PRODUCT / PROCESS CHANGE NOTIFICATION

PCN-000712

P/N TS30041-M0XXQFNR & TS30042-M0XXQFNR

PCN No. 000712
Qualification of Carsem Ipoh for TS3004X-M0XXQFNR
products

SEMTECH Package Outline on TS3004X-M0XXQFNR CarsemSZ (Old) and CarsemIPH (New)

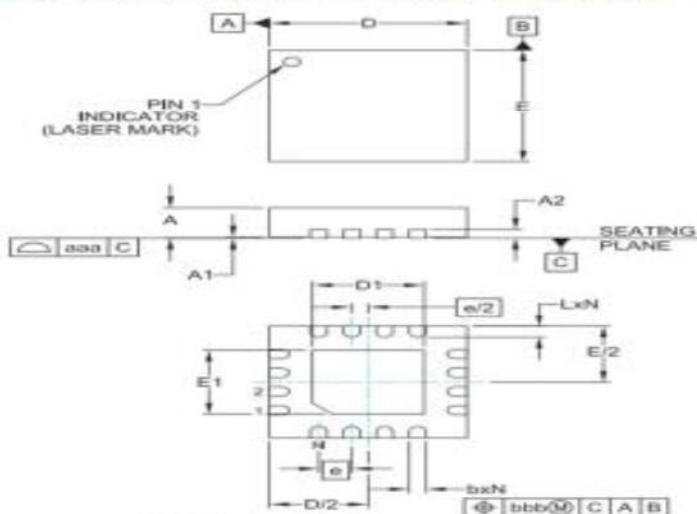
**No Change in
Package Outline.**

BOM Comparison CarsemSZ (Old) vs CarsemIPH (New) for TS3004X-M0XXQFNR

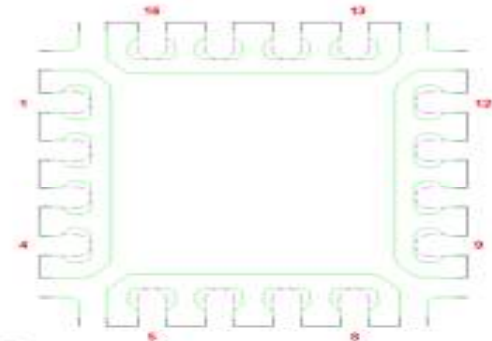
- BOM for both supplier CarsemSZ and CarsemIPH are no difference.

**Bonding Layout (CarsemSZ vs
CarsemIPH) for TS3004X-M0XXQFNR**

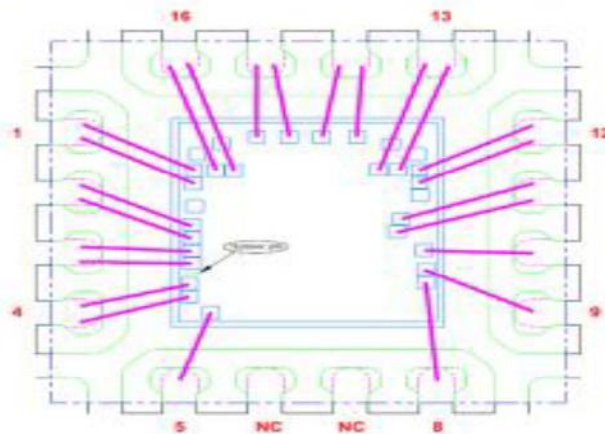
No Change in Bonding Layout.
